South Texas Project Electric Generating Station P.O. Box 289 Wadsworth, Texas 77483

February 1, 2010
U7-C-STP-NRC-100034

South Texas Project
Units 3 and 4
Docket Nos. 52-012 and 52-013
Supplemental Response to Request for Additional Information

RAI 06.02.01.01.C-13 Supp

Figure 1 Influence of Node Size on Pool Swell

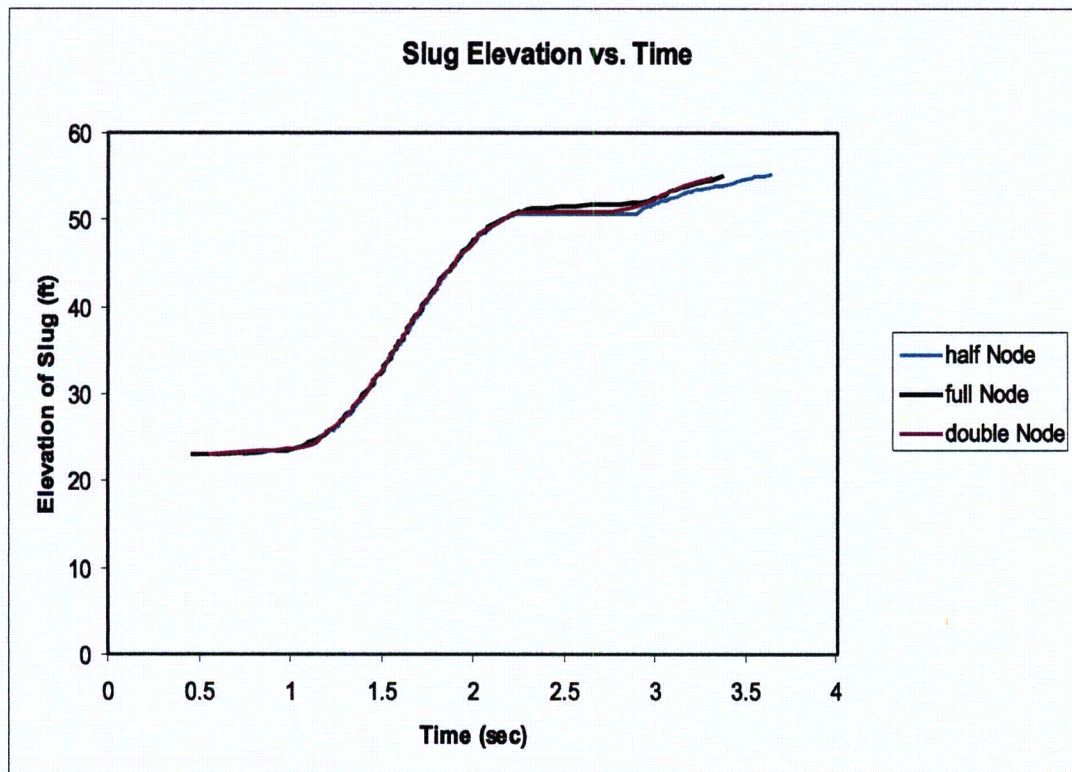
In the pool swell analysis (UTLR-0005-P Rev 0 (September 2009)), the wetwell node size is limited to a specific fixed value. Please provide:

- a) basis for the choice of this value,
- b) discussion on potential effect of different node sizes on pool swell behavior,
- c) basis and/or rational for selection of the maximum bubble size,
- d) discussion on potential effect of different bubble size, including the effect of the bubble size that does not coincide with the calculational node size

- b) The GOTHIC model was modified to investigate the effects of using different nodes sizes on the pool swell and swell velocity. Node sizes of one-half and two times the selected node size were used to perform calculations for comparison with the results for the selected node size as documented in UTLR-0005-P Rev. 0. Figures 1 and 2 show the pool swell height and the surface velocity for the three cases. The results show that the pool swell and swell velocity are not very sensitive to node size within the sensitivity study range (one-half to two times node size). The variance in the maximum swell elevation is within the data extraction uncertainty (one node height).
